29 January 2019

Our Ref L/0006/2019-01/AMD-AD

Code of Practice 101 for Distribution Substation Design (COP101)
Update No. 3/2019 – Fall Restraint System and Anti-Flooding Requirement

TYPICAL UPPER FLOOR SUBSTATION SECTIONS

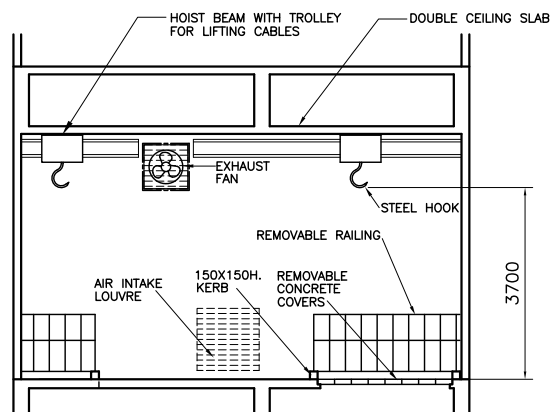
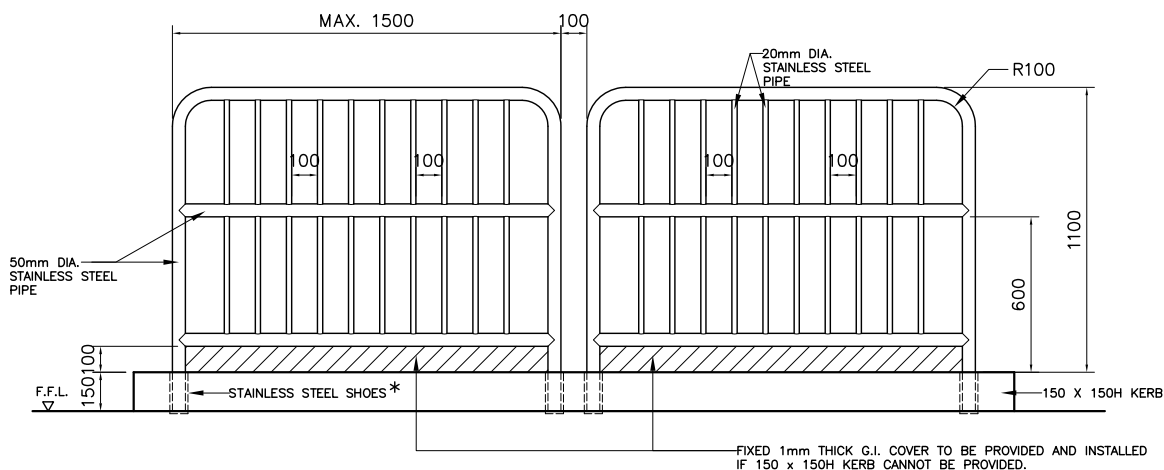
1. Revision of drawing - T-COP-10250-D-E33-0101-09-E-A
(Note updated.)
2. Revision of drawing - T-COP-10250-D-E33-0101-13-K-A
(Anchor points and fixed railing added. Note added.)

TYPICAL DETAIL OF REMOVABLE RAILING AND NOTE ADDED.

*2. STAINLESS STEEL SHOES WILL NOT BE REQUIRED IF IT IS A FIXED RAILING.

TYPICAL UPPER FLOOR SUBSTATION LAYOUT FOR HOUSING ONE TRANSFORMER WITHOUT VEHICULAR ACCESS (INDEPENDENT STAIRCASE)

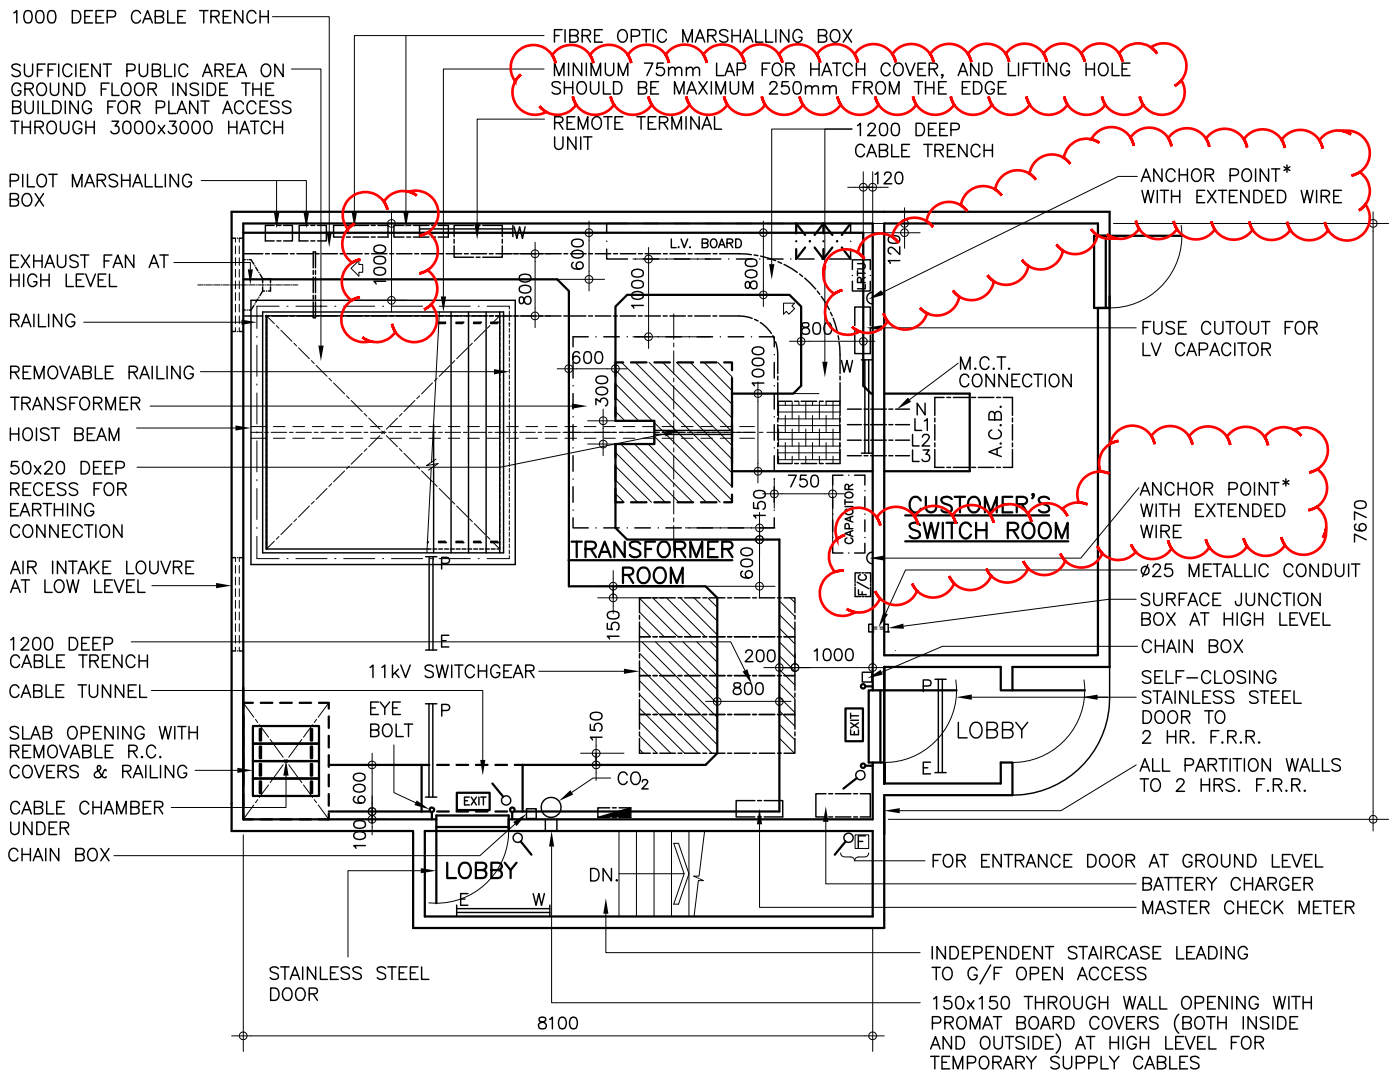
K	ANCHOR POINT AND FIXED RAILING, NOTE ADDED.
J	GENERAL LAYOUT REVISION
H	SYMBOLS, DEPTH OF CABLE TRENCH CONDUIT, FIRE EXTINGUISHER, MASTER CHECK METER ADDED.
G	FUSE CUTOFF ADDED, DOOR, TRANSFORMER, HV SWITCHGEAR AND G.I. SLEEVE SIZE UPD.
F	CHAIN BOX ADDED AND CABLE TRENCH LADDER DELETED
E	PHASE IDENTIFICATION UPDATED AND CABLE TRENCH LADDER ADDED
D	AIR INTAKE LOUVRE AND FAN CONTROL PANEL RELOCATED
C	LRTU ADDED
B	GENERAL LAYOUT REVISION

- *1. DESIGN OF FALL RESTRAINT SYSTEM SHALL FOLLOW THE TYPICAL DRAWING T-COP-10250-D-E33-0103-38.
2. IF THE PROVISION OF FALL RESTRAINT SYSTEM IS NOT REASONABLY PRACTICABLE, FALL ARREST SYSTEM SHALL BE PROVIDED AS THE LAST RESORT.

TYPICAL DETAILS FOR UPPER FLOOR
SUBSTATION WITH RETRACTABLE HOIST BEAM
AND TROLLEY

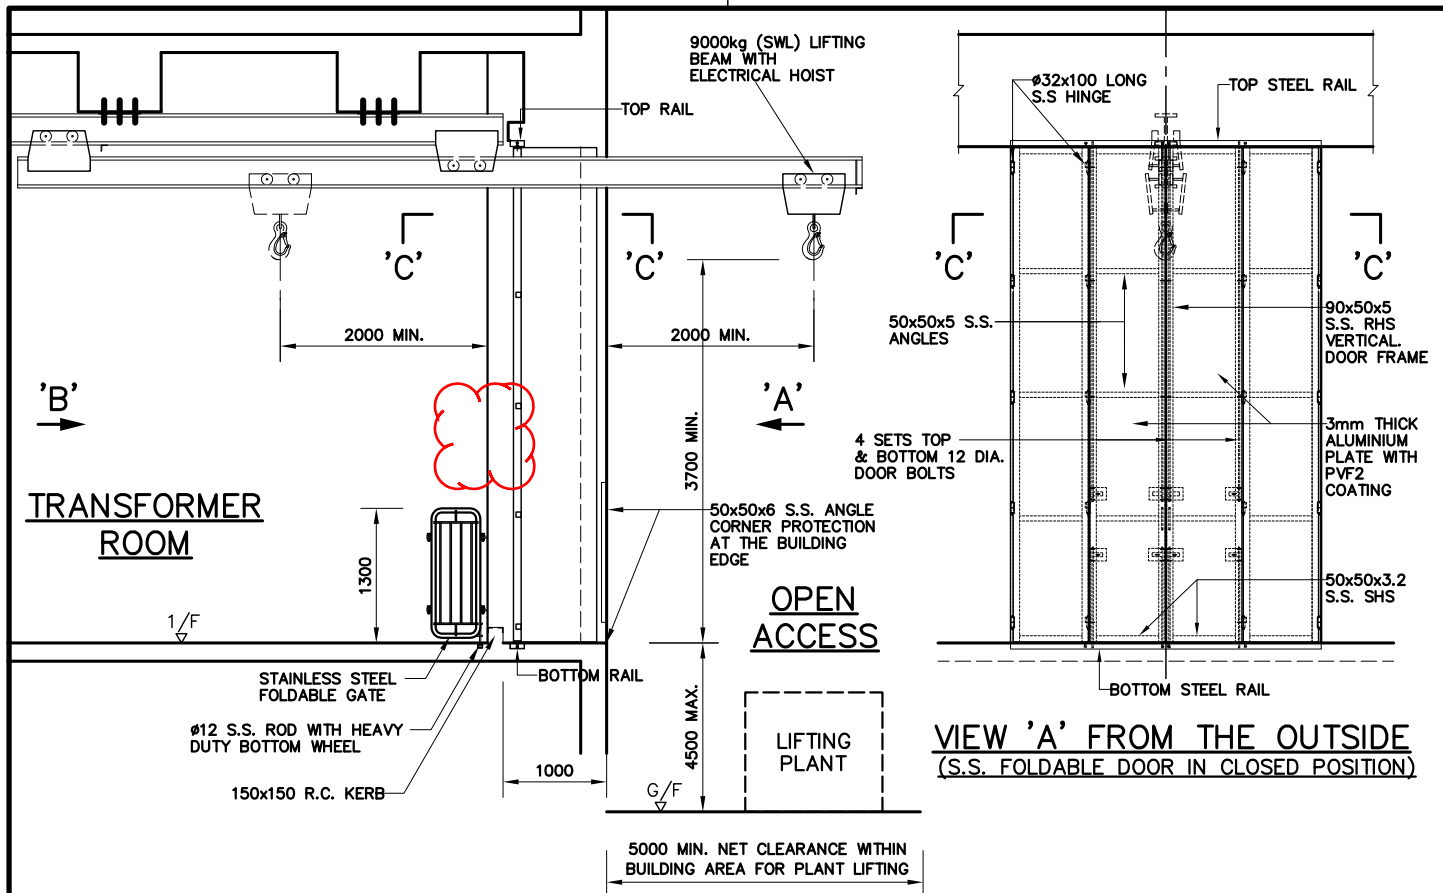
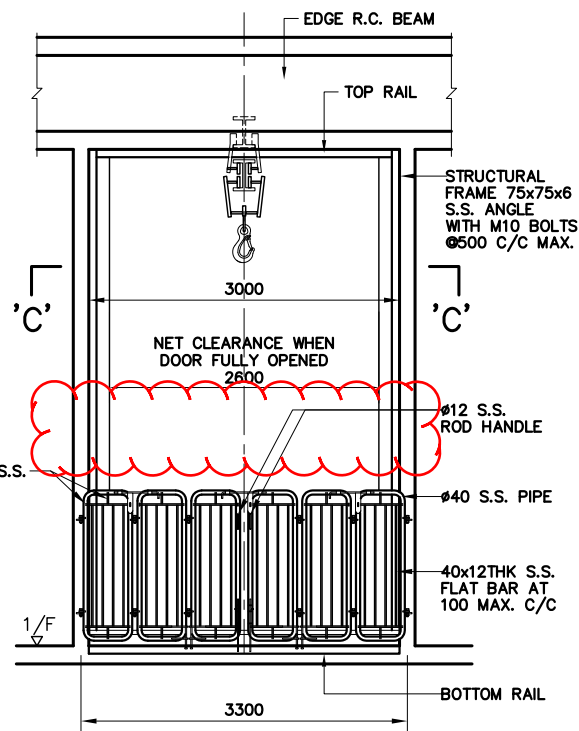
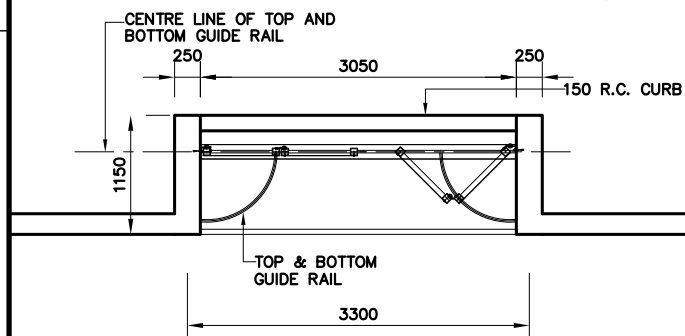
<ol style="list-style-type: none">3. Revision of drawing – T-COP-10250-D-E33-0103-32-A-A (Anchor points deleted. Note added.)4. New drawing – T-COP-10250-D-E33-0103-38-A (Typical Design of Fall Restraint System)5. New drawing – T-COP-10250-D-E33-0103-39-A (Typical Design of Ground Floor Entrance for Basement Substation)
--	---

A ANCHOR POINTS DELETED, NOTE ADDED.

5. RUBBER WEATHER PROOF STRIPES SHALL BE PROVIDED TO PREVENT INGRESS OF RAIN WATER DURING THE SEVERE RAINING CONDITION.
6. DESIGN OF FALL RESTRAINT SYSTEM SHALL FOLLOW THE TYPICAL DRAWING T-COP-10250-D-E33-0103-38.

7. IF THE PROVISION OF FALL RESTRAINT SYSTEM IS NOT REASONABLY PRACTICABLE, FALL ARREST SYSTEM SHALL BE PROVIDED AS THE LAST RESORT.
8. ALL DIMENSIONS ARE IN mm.
